# Access Compliance Report

## Public Rights-of-Way

### (Curb Ramps)

Intersection ID: 10143	Main Street: E_34TH_ST	Cross Street: N_DAVIDSON_ST	Location: S
ADA ID: 7837A4A29F7B	Ramp Type: PerpDiag	Initial Pass/Fail: Fail	Overall Compliance: No
Severity Score: 12.5			
Codes/Mitigation Info/Possible Solution		Field Measurements/Component Compliance

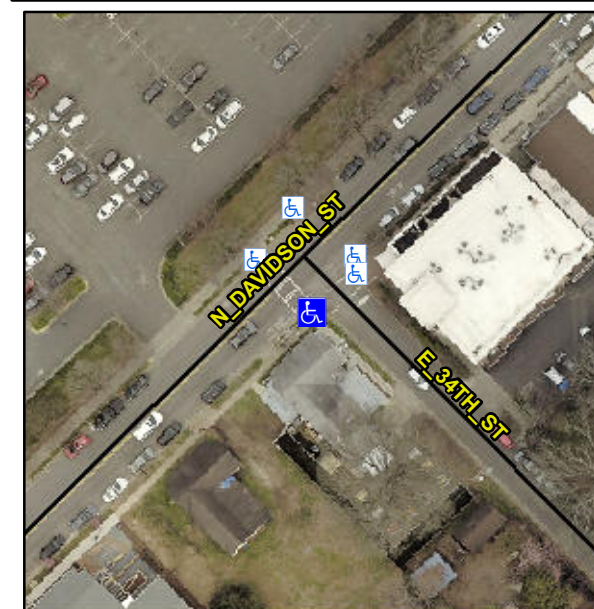
Compliance	Description	Data	Compliance	Description	Data
N/A	Ramp Length (in)	33.0	No	Ramp Slope (%)	11.4
Yes	Ramp Width (in)	72.0	Yes	Ramp XSlope (%)	1.1
N/A	Flare Type LT	N/A	N/A	Flare Type RT	N/A
N/A	Flare Slope LT (%)	N/A	N/A	Flare Slope RT (%)	N/A
N/A	Flare Traversable LT?	N/A	N/A	Flare Traversable RT?	N/A
N/A	Landing Length (in)	N/A	N/A	DWS Provided?	N/A
N/A	Landing Width (in)	N/A	N/A	DWS Contrast?	N/A
N/A	Landing Slope (%)	N/A	N/A	DWS Length (in)	N/A
N/A	Landing X Slope (%)	N/A	N/A	DWS Full Width?	N/A
N/A	Landing Curb? (Y/N)	N/A	N/A	DWS Offset (in)	N/A
N/A	Shared Landing?	N/A			
N/A	Gutter Ponding?	N/A	N/A	Gutter Slope (%)	N/A
N/A	Gutter Lip Ht (in)	1.0	N/A	Gutter X Slope (%)	N/A
N/A	Painted X Walk1?	Yes	N/A	Painted X Walk2?	Yes
	X Walk 1 Direction	To NE		X Walk 2 Direction	To NW
N/A	X Walk 1 Width (in)	106.0	N/A	X Walk 2 Width (in)	111.0
	X Walk 1 Slope (%)	2.1		X Walk 2 Slope (%)	4.3
	X Walk 1 X Slope (%)	2.7		X Walk 2 X Slope (%)	0.0

N/A	Ramp inside XWalk1?	Yes	N/A	Ramp inside XWalk2?	Yes
	Road Slope (%)	0.1	N/A	Clear Space?	N/A
	Road X Slope (%)	3.1	N/A	Clear Space to XWalk (in)	N/A
N/A	Any Obstructions?	N/A	N/A	Storm Grate/Utility Hazard?	N/A
	Obstruction Type			Storm Grate/Utility Type	
		N/A			N/A
		Yes		Surface Condition? (G/P)	Good

**Remove & Replace Curb Ramp With Two New Directional Ramps or Equivalent.**

**R304.2.2**
